NEWTON STEWART FLOOD PROTECTION SCHEME

VM DOCUMENT

25 AUGUST 2017

Change list

Figure 2-10 - Gravel Berm

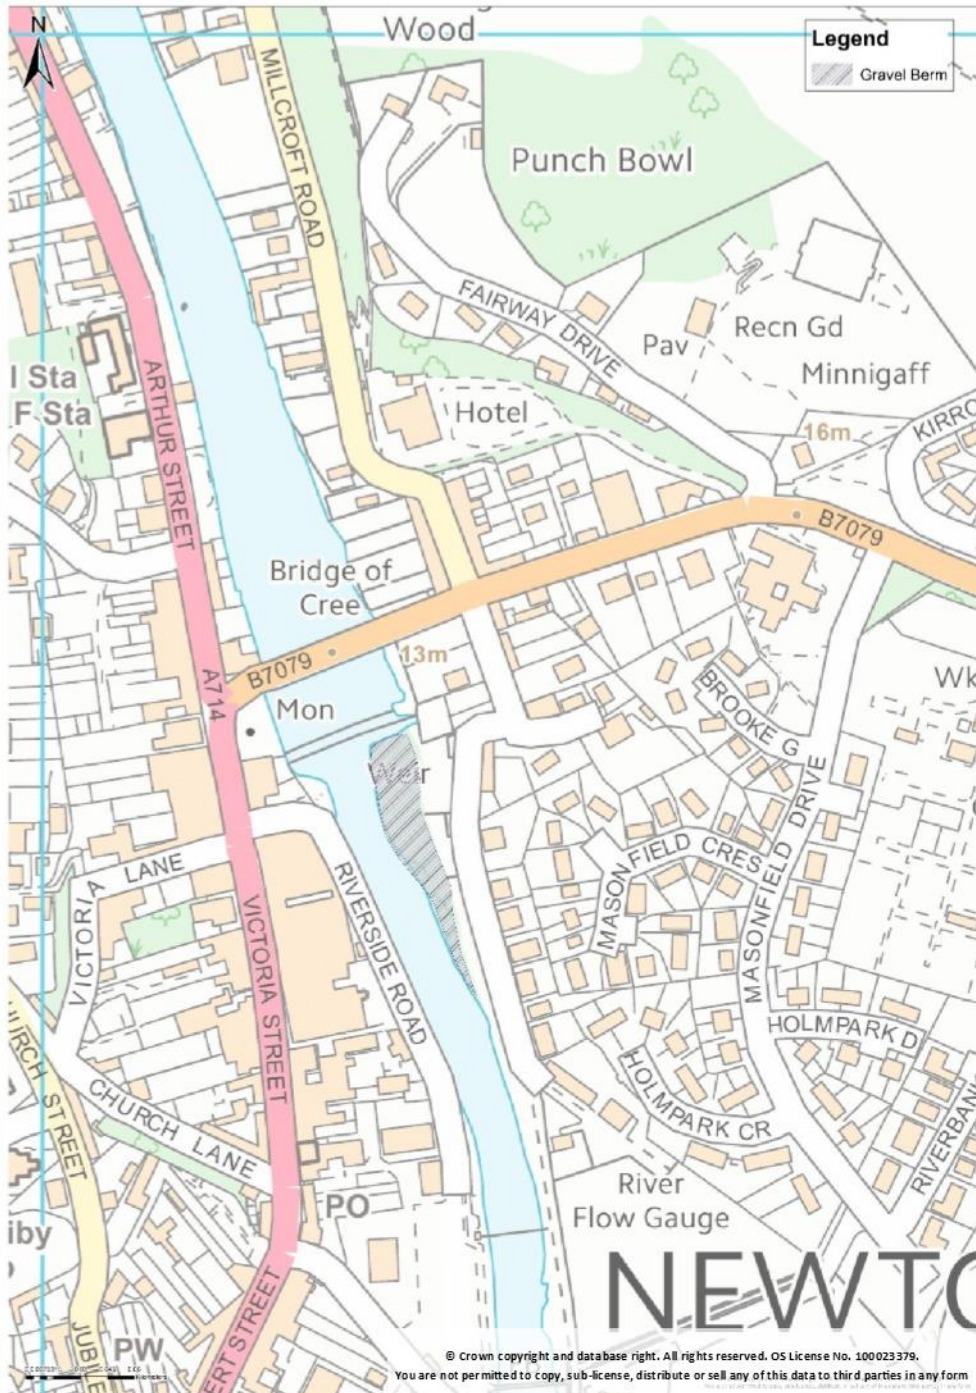
The CVCC representatives at the VM1 meeting commented on the strong feeling from the community that this berm should be removed. It is felt that there has been a substantial change in the height of the berm over time and this has contributed to flood risk. There are also a two further islands that are also thought, within the local community, to result in flow backing up throughout the town. This may be exacerbated by the presence of vegetation and trees, the growth of which is facilitated by the presence of the gravel berm. CVCC also noted a preference for this option in their letter to DGC ahead of the VM1 meeting, as they felt it pushes water over towards the western bank adding pressure to the wall at Riverside Road.

Kaya Consulting felt that, taking into account the hydraulics of the system as a whole, the impact of removing the gravel berm on flood risk would in fact be minimal. Reference is made to the initial modelling exercise that looked into this and found low impact following removal.

DGC felt that any removal of trees on the berm could result in a negative visual impact for those with properties on the east side of the river. They also noted that historical mapping has shown the berm to always be there.

SEPA noted that a CAR license would be required to remove this material from the river. Authorization for this would be possible, however monitoring of the build-up would be needed in the first instance and a benefit to flood risk would need to be demonstrated.

Given that modelling shows that removal of the gravel berm and associated vegetation has very little impact upon flood risk, DGC would not consider its removal is merited with respect to duties imposed by Section 18 of the Flood Risk Management (Scotland) Act 2009. In

other words the gravel island removal is not considered to substantially reduce the risk of flooding.

Figure 2-15 - In-Channel Structures

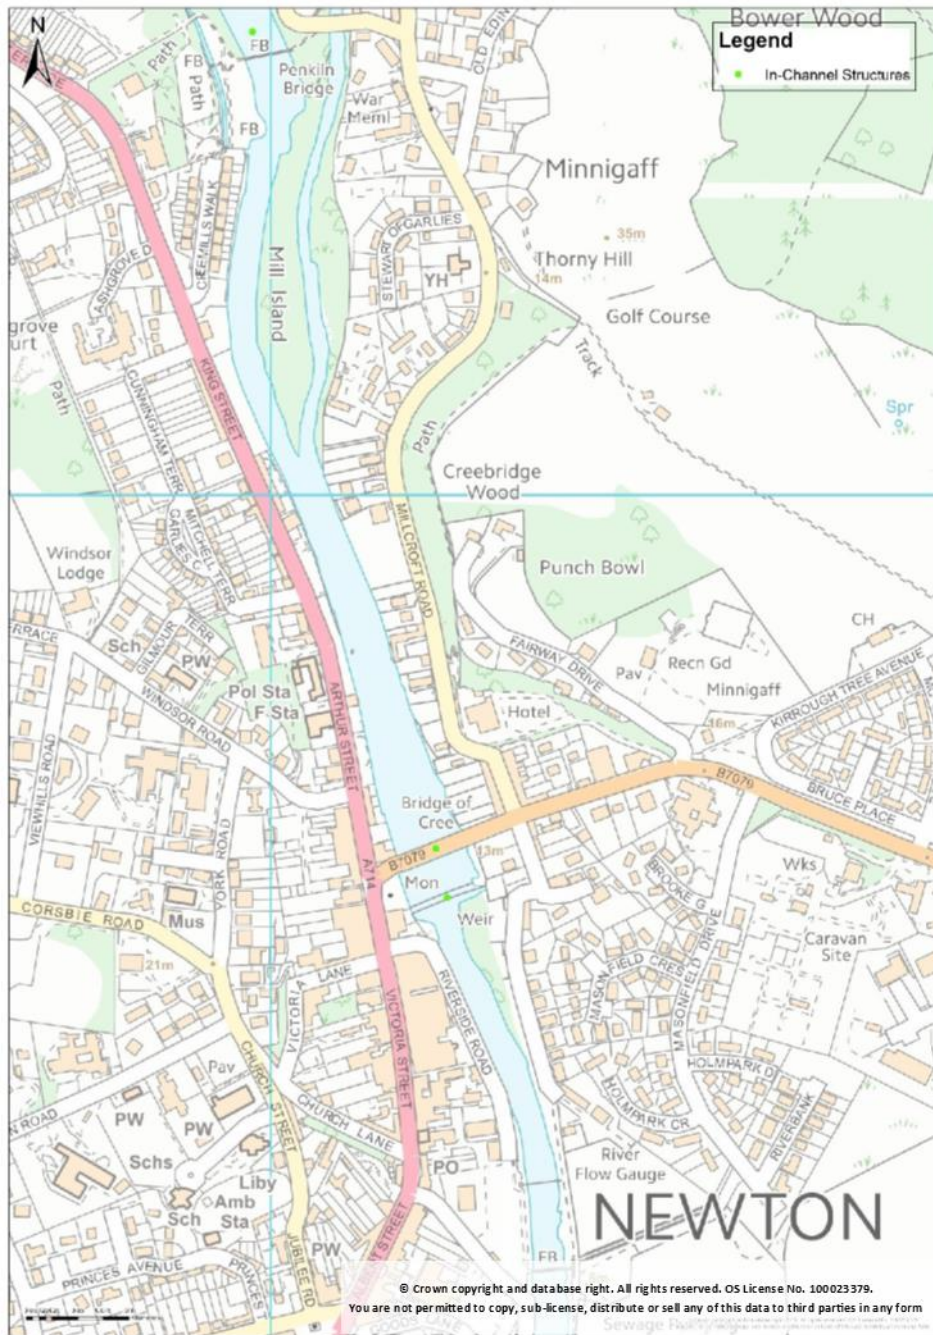
CVCC noted in their letter to DGC ahead of the VM1 meeting that they felt it would be valuable to remove the stone deposits within this area.

Figure 2-17 - Areas of Dredging Potential

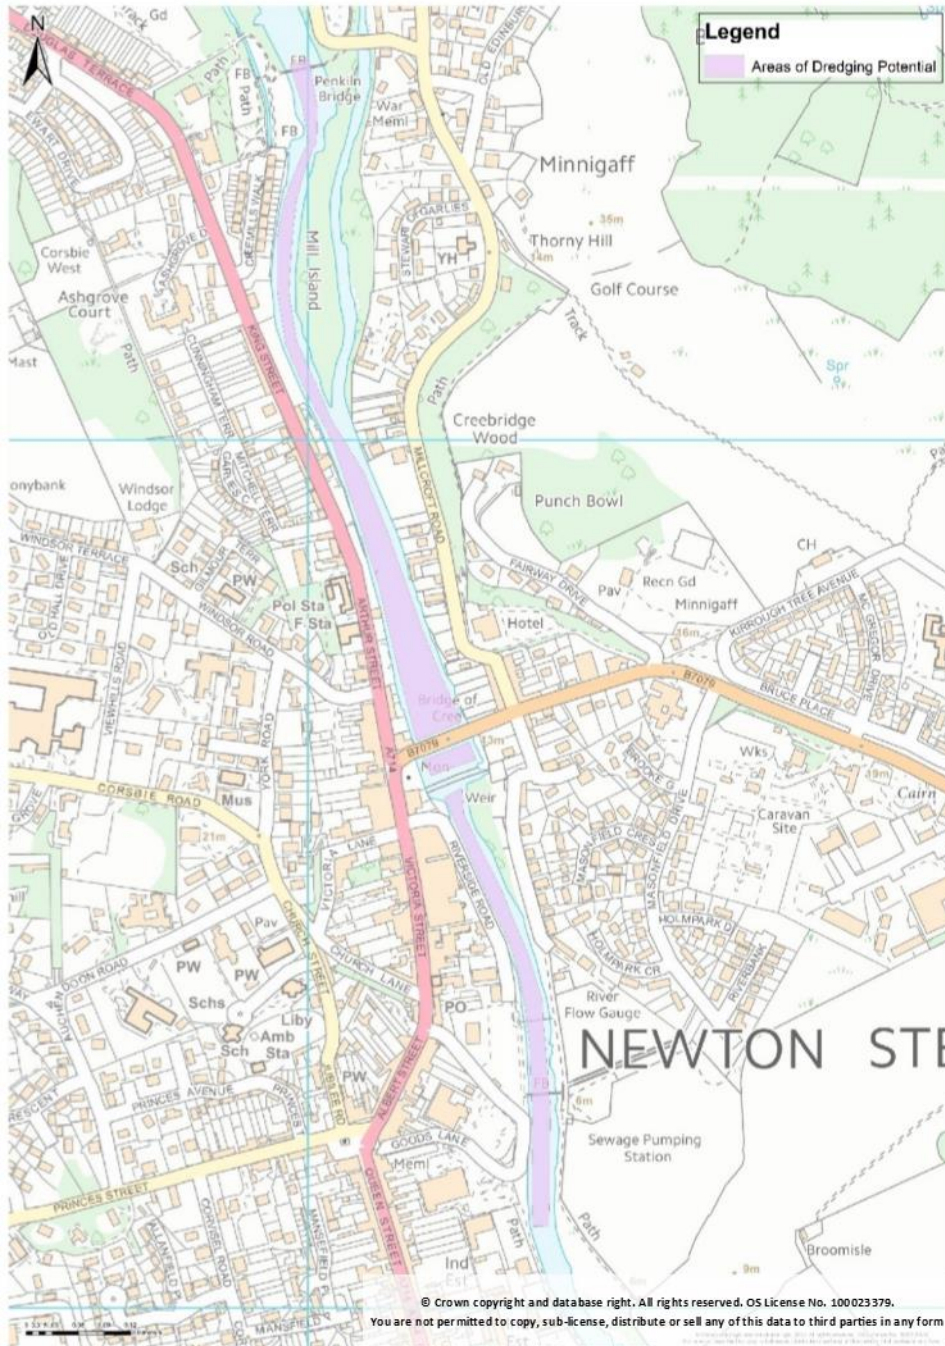
SEPA noted that a CAR license would be required. Authorization for this would necessitate the provision of a sediment management plan such as to show the dredging as a regular occurrence in the future. Therefore, as a whole life cost this option was considered to be unsustainable.

Figure 2-19 - Broomisle Area

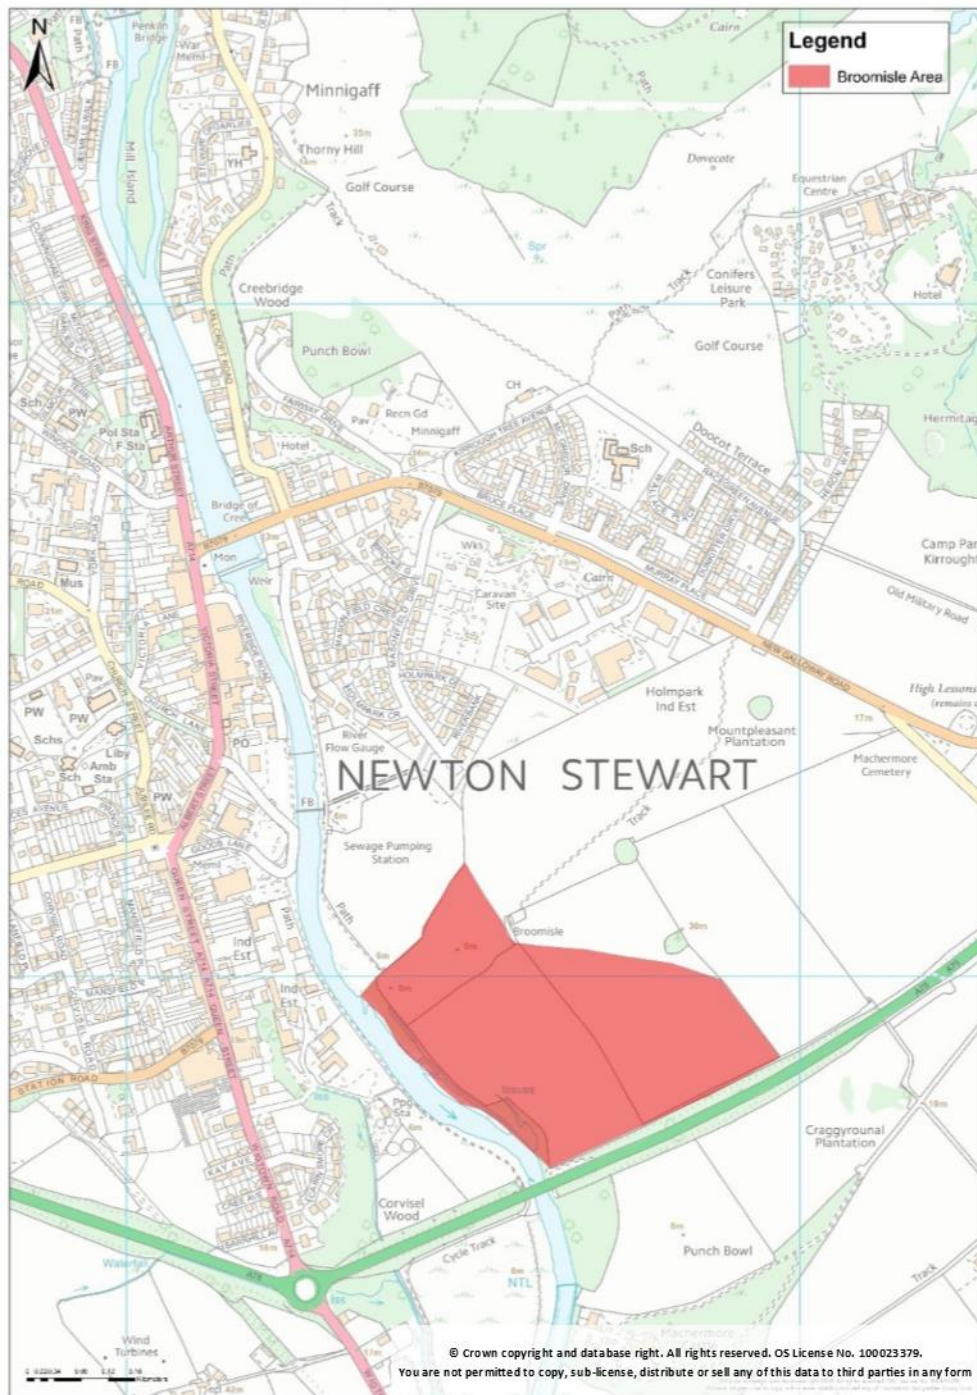
CVCC noted in their letter to DGC ahead of the VM1 meeting that increasing access to additional areas of floodplain from the river is an important issue (suggesting support for this option). No specific further feedback was gained at the VM1 meeting itself, but the general consensus was that this area was worth looking into in more detail.

Figure 2-23 - Hydrological Catchment and Forestry

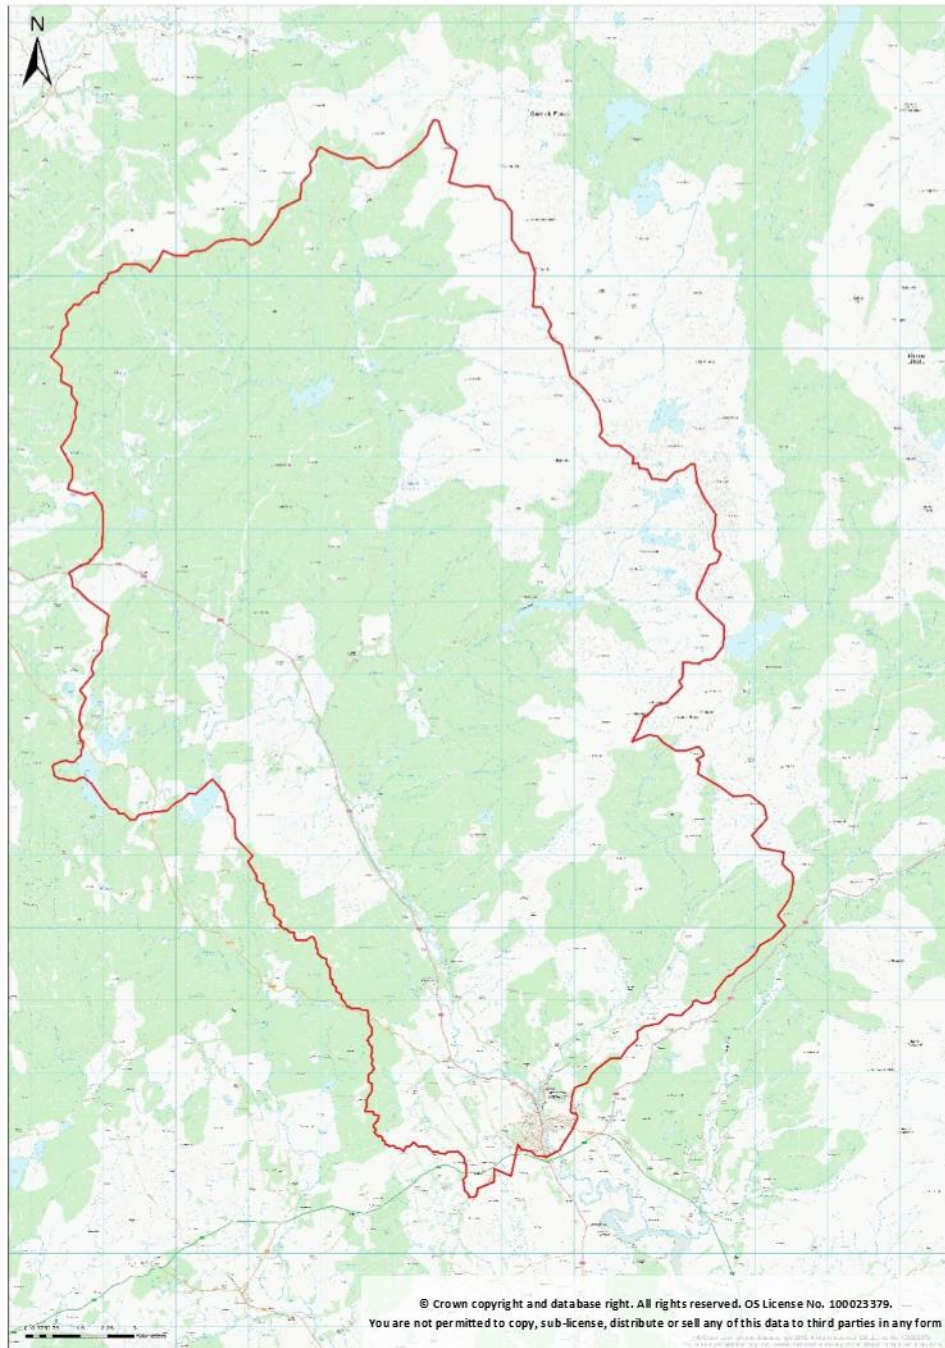
Forestry Commission Scotland noted that the current forestry management practises are in line with NFM practises and that their work actively alleviates flooding. They believe that there is nothing further or additional that could be done, and would be happy to discuss their management plans to show that is currently being undertaken.
